GTR on Motorcycle Braking - India's concerns

Justification for Clause 4.4.3 of the Draft GTR on Dry Stop test :

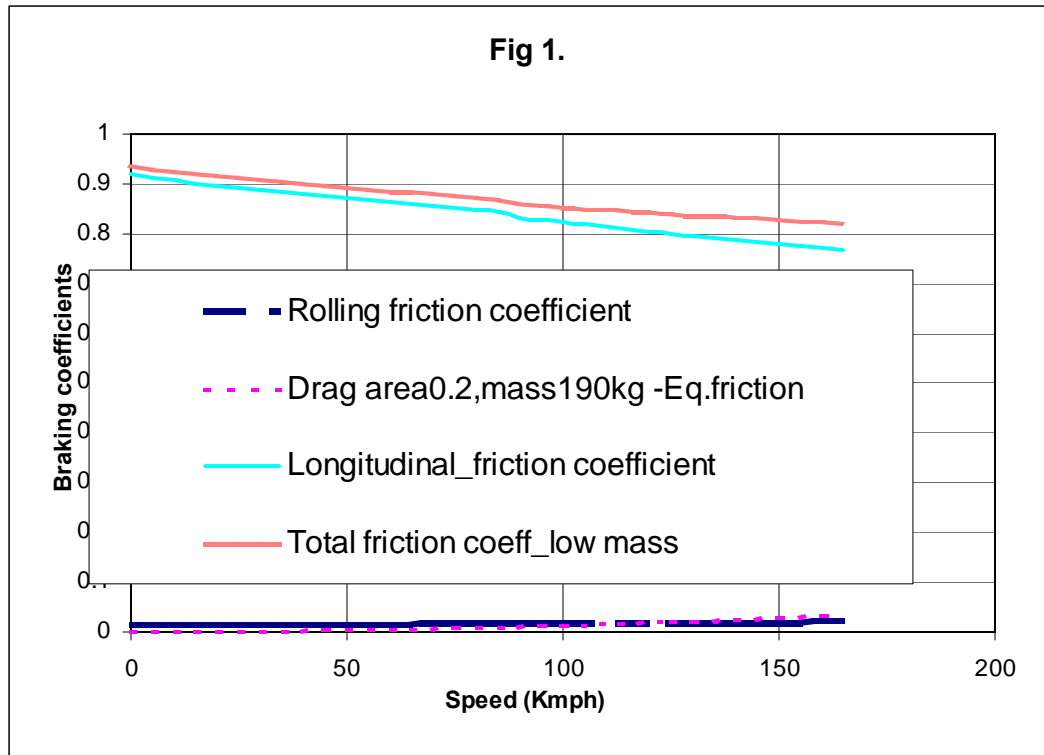
- (i) **Drop in sliding friction coefficient at higher speed :** For test speeds from 40 km/h to 160 km/h the drop in sliding coefficient is of the order of 14 %. If the effect of rolling and aerodynamic resistance coefficient are also considered then the total drop in total braking coefficient is about 9%. This is indicated in the following Figure-1 based on Internationally published data.

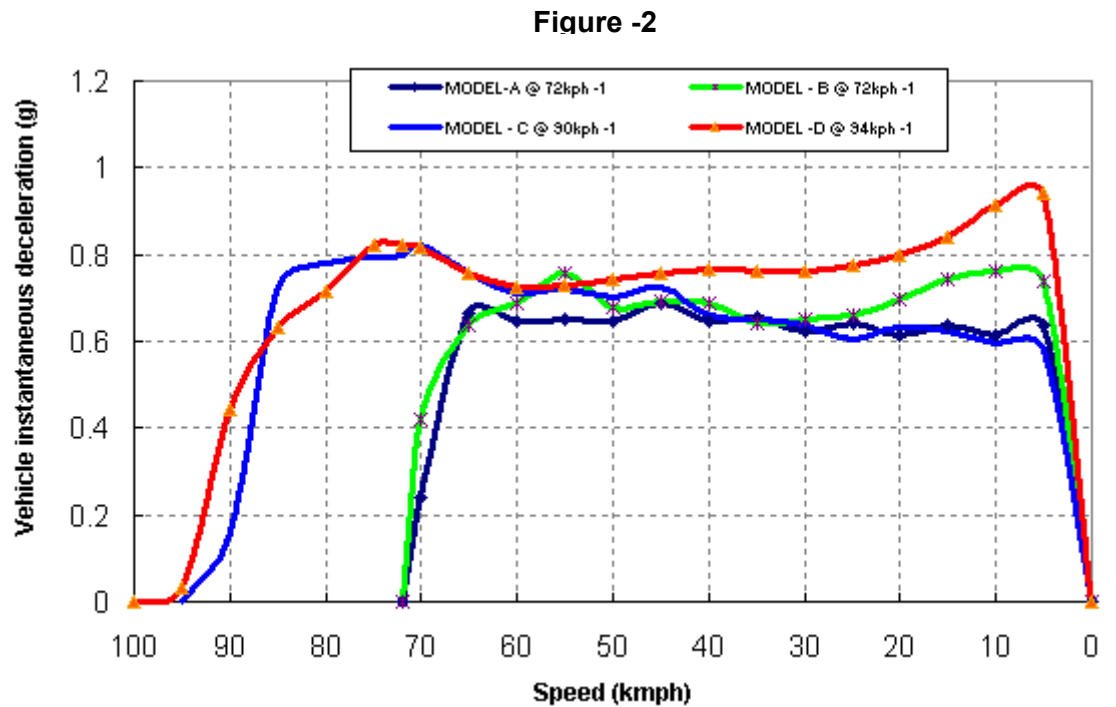
- (ii) **Variation in vehicle instantaneous deceleration :** It may be observed that instantaneous deceleration values do not remain steady at 0.8 g during the entire process of braking. The values of the instantaneous deceleration drops down to a speed upto 20 km/h and then gradually shoots up. This phenomenon is observed and supported by the following Figure -2, for 4 representative vehicle models.

Figure – 3

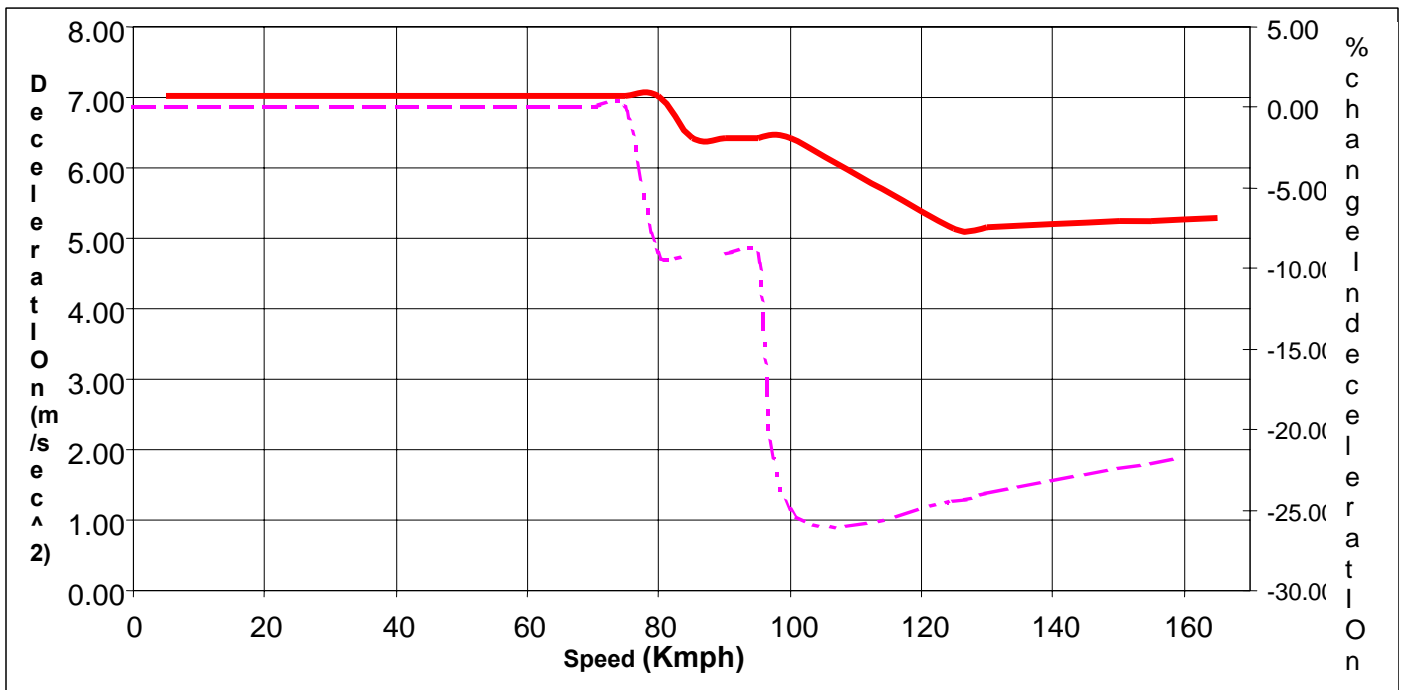
(iii) **Change in deceleration values for speeds below 80.5 km/h and speeds above 80.5 km/h :** Based on the proposed values of GTR, it may be seen from Figure-3 that , for vehicles upto 80.5 km/h there is no change in the requirements for deceleration values, i.e. 7.01 m/s². But the increase in average deceleration calculated from GTR is 12% for 80.5 to 100 km/h and about 21% for 100 km/h to 160 km/h, when tested for the high speed test as per clause 4.5 of the Draft GTR. Whereas the drop in 'total braking coefficient' considering the effect of rolling resistance and the aerodynamic resistance is 9% only. So any vehicle, which has test speed falling between 40.0 to 80.5 km/h, has to meet a more stringent requirement. This is supported by the following Figure – 3.

Figure – 4

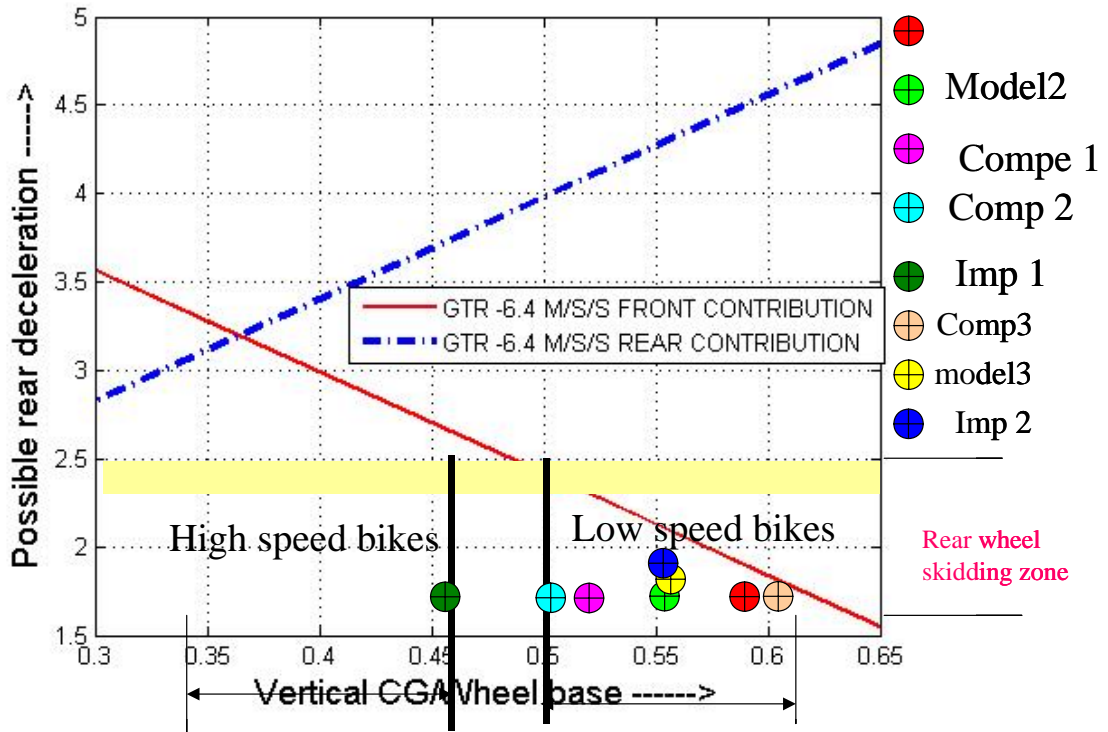
- (iv) **Effect of ratio of vertical (height of) CG / Wheel base, on Indian vehicles :** The wheel base and the height of CG is also a major contributing factor towards the effect of braking, both the front and the rear brakes in the dynamic condition. It may be seen from the following Figure 4, that the contribution from the rear brakes decreases with increase in vertical CG / wheel base, which largely affects the performance requirements at high speeds.

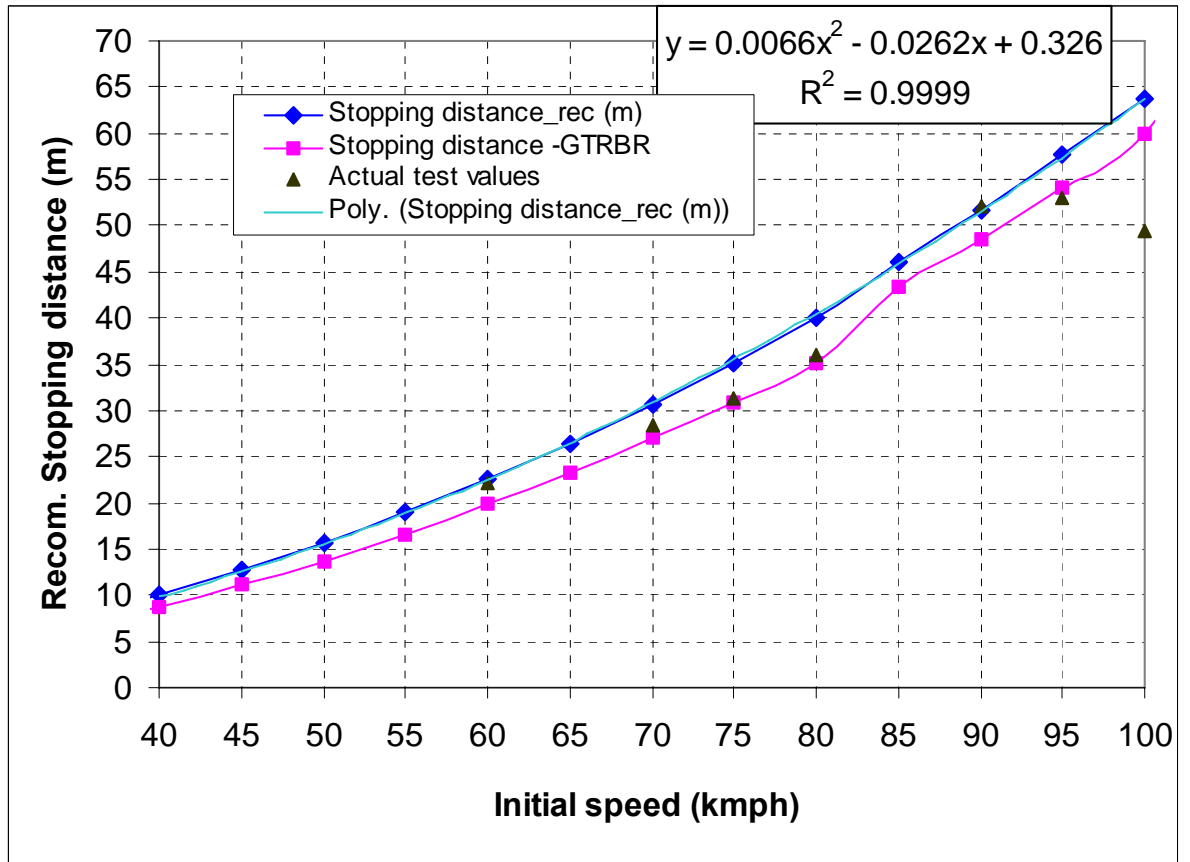
The above proposal is stricter than ECE for 40 to 100 km/h. and closer to FMVSS. This is further explained by the following Figure - 5. From the above proposal a deviation of 12% occurs for test speeds from 40 km/h to 80.5 km/h and a deviation of 6% occurs for test speeds from 80.5 to 100 km/h.

In today's situation all our Indian vehicles are meeting the ECE requirements and we have not come across any adverse issues affecting safety on this front. We strongly propose the following equation for stopping distance based on the factors such as total braking coefficient, high speed braking tests as per GTR and the shorter wheel bases of Indian vehicles.

Stopping distance, $S \leq 0.0066 V^2 - 0.0262 V + 0.326$, in metres
